# DART SERVICE INSTRUCTION

TO AMEND INSTALLATION INSTRUCTIONS II145-6 Rev. A or later,  
REF. TCCA STC: SH21-24  
REF. EASA STC: 10077436  
REF. FAA STC: SR04694NY

B	REVISED WIRE CALLOUTS, ADDED FUNCTIONAL TEST	CZ	22.10.07
A	NEW ISSUE	CZ	22.09.01
REV.	DESCRIPTION	BY	DATE
DESIGN	CZ	<b>DART AEROSPACE LTD</b> HAWKESBURY, ONTARIO, CANADA	
DRAWN	CZ		
CHECKED	JG	DRAWING NO.	REV. B
MFG. APPR.	N/A	DSI 9875	SHEET 1 OF 4
APPROVED	JG	TITLE	SCALE
DE APPR.	DS 	RELAY UPGRADE KIT	NTS
DATE	22.10.07	COPYRIGHT © 2022 BY DART AEROSPACE LTD. THIS DOCUMENT IS PRIVATE AND CONFIDENTIAL AND IS SUPPLIED ON THE EXPRESS CONDITION THAT IT IS NOT TO BE USED FOR ANY PURPOSE OR COPIED OR COMMUNICATED TO ANY OTHER PERSON WITHOUT WRITTEN PERMISSION FROM DART AEROSPACE LTD.

FIGURE 2: RH CABLE CHANNEL RELAY INSTALLATION LOCATION

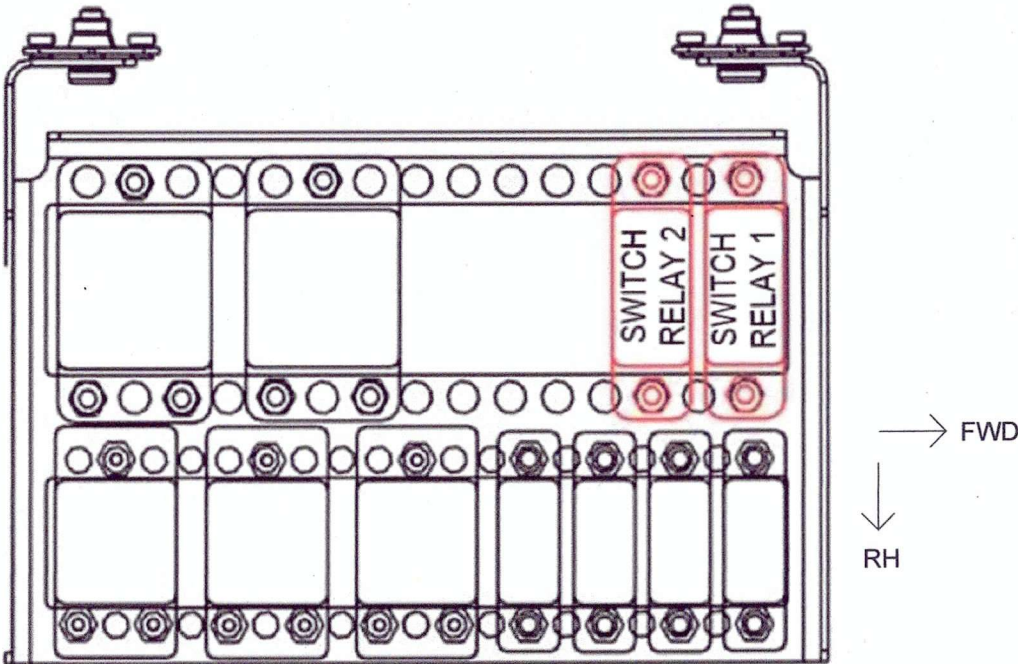
1. Install two relay sockets (P/N 601.1682) into the relay holder in the cable channel on the FWD RH side of the aircraft as shown in Figure 1 and Figure 2 of this DSI.

2. Install two relays (P/N 601.1627) into the relay sockets.
3. Routing for Switch Relay 1:
  - a. Route wire 4102-M20 from the Instrument Panel to the relay at pin A2.

1. Install one relay socket (P/N 601.1682) into the relay holder in the cable channel on the FWD RH side of the aircraft as shown in Figure 1 and Figure 2 of this DSI.
2. Install one relay (P/N 601.1627) into the relay socket.
3. Route wire 4102-M20 from the Instrument Panel to the relay at pin A2.
4. Splice wire 4101-M20 to SPDA9 and route to the relay pin X1.
5. Route wire 4103-M20 from splice SPDA1 to the relay pin X2.
6. Splice wire 4125-M20 to SPDA6 and route to relay pin A1.
7. From splice SPDA6, route wire 4107-M20 to connector pin A and wire 4124-M20 to connector pin C.
8. Wire 4104-M20 that is spliced to SPDA2 will now be routed to SPDA8 and from there to ground.

1. Install one or two relay sockets (P/N 601.1682) into the relay holder in the cable channel on the FWD RH side of the aircraft as shown in Figure 1 and Figure 2 of this DSI.
